Drawing status FOR COMMENT

County Flats, Sandfields

1231

Flat Type Coz.2

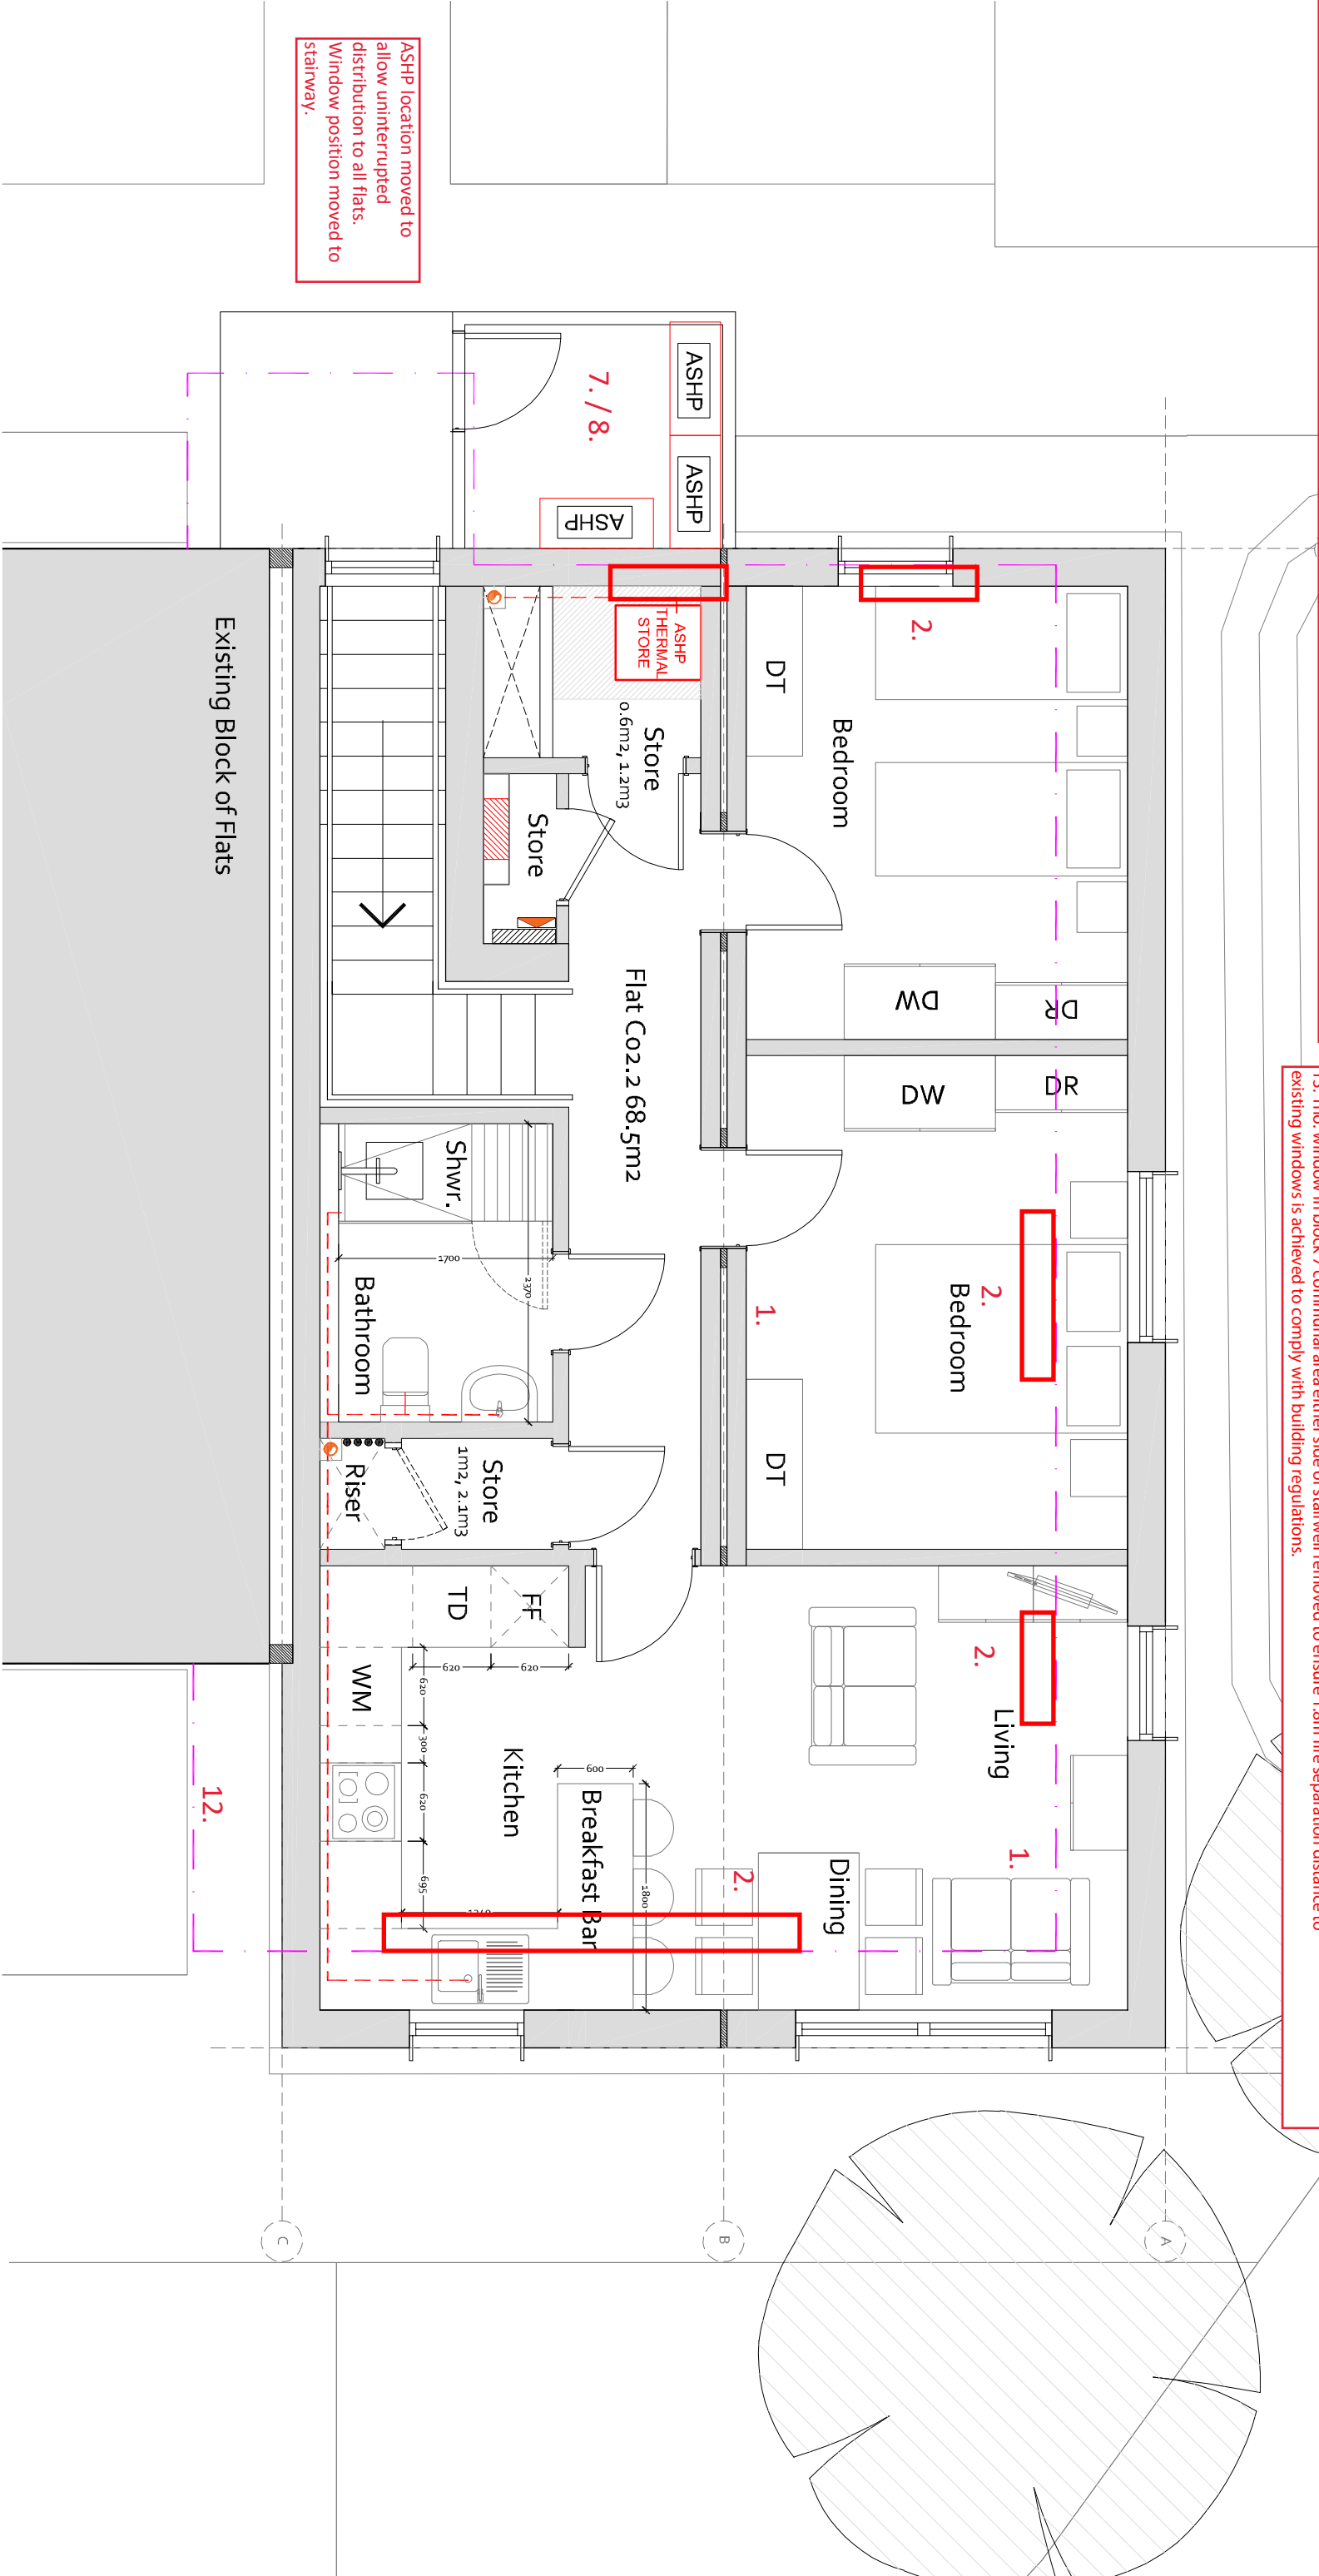
- DESIGN CHANGES
1. Modular end links re-positioned slightly off existing buildings, with the party wall straightened and porch projections aligned with this wall, to ensure modular construction can be achieved off site.

2. Windows have been slightly re-positioned to the new build to suit the structural design of the modular units and the constraints of the timber frame.

3. Parapet to modular end blocks have been lowered by approx 900mm to comply with the structural wind loadings and timber frame design.

4. Corner windows have been removed and replaced with 2no. Windows on either corner, again due to the structural and timber frame design of the blocks.

5. PV panels have been omitted from the end modular units to suit the structural and timber frame design of the blocks.

6. Ground floor Juliet balcony added to existing flats to provide better security whilst ensuring the open areas remain as communal spaces.
7. Air source heat pump external louvre enclosure amended to be single storey over entrance canopy to end link blocks.

8. External air source lowered enclosure handed to provide internal riser/access requirements for maintenance.
9. Buggy/cycle store added to block 6 and 7 parking courtyards.

10. Bin stores slightly re-positioned to suit existing drainage runs, with bin store near block 6 amended in size to suit located of bedroom window.
11. Footpaths amended to be Tarmac.

12. Windows in communal area to the linked blocks made narrower to ensure 1.8m fire separation distance to existing windows is achieved to comply with building regulations.

13. 1no. window in block 7 communal area either side of stairwell removed to ensure 1.8m fire separation distance to existing windows is achieved to comply with building regulations.
